Verizon Fios Proposal

MEMO TO: Parkfairfax Board of Directors
FROM: Mike Rothenberg, Ward 1 Board Representative & BUC Liaison
SUBJECT: Verizon and Ting Agenda Item
DATE: June 21, 2024

Pathway Creation Design

OUTDOOR LAYOUT SHOWING EXISTING PATHWAYS ACROSS ENTIRE DEVELOPMENT

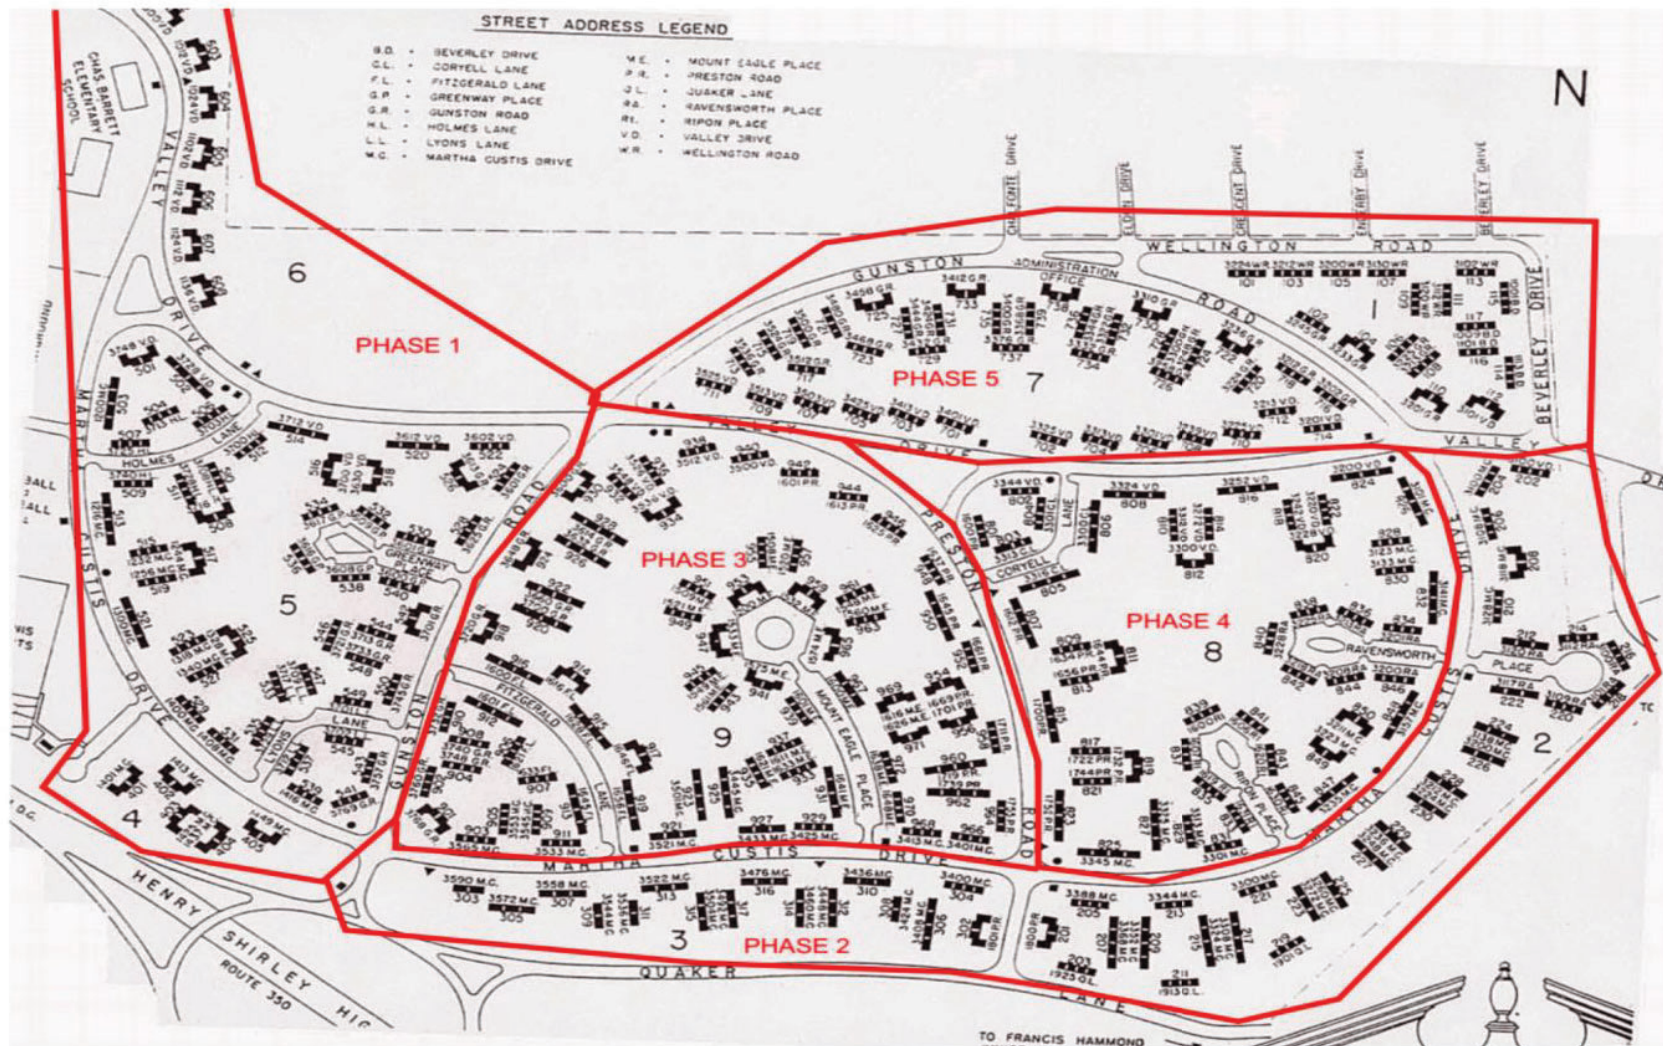
- There is agreement that these submissions are not proposals, but rather engineering diagrams showing where each entity wants to lay fiber in the community -- under streets, sidewalks, lawns.

- There is nothing in their docs, for example, about remediation, whether or not they will go around tree roots or cut right through them.
- There is no mention as to what services will be offered (Will Verizon also offer its FIOS video streaming services in addition to internet), what the pricing will be, nor any commitment concerning technical quality of service or quality of customer service.

CONNECTED ATTIC

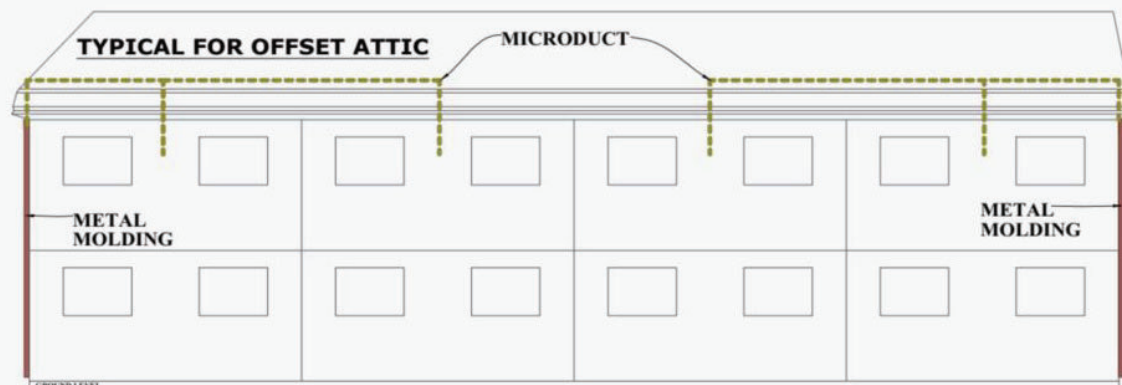
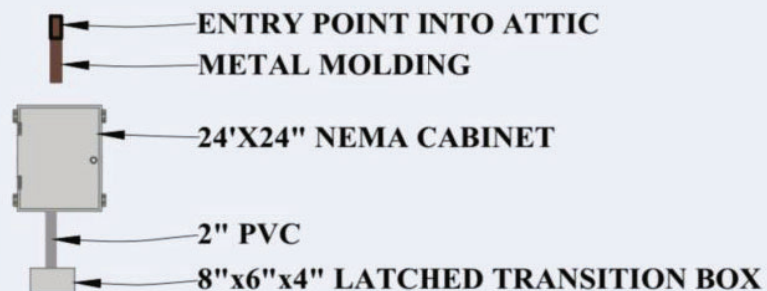
- Also, Verizon mentions running the fiber cable the width of buildings in the attics, which raises concerns about how this could impact the decommissioned pipes wrapped in asbestos insulation and residents' use of the attics for storage.
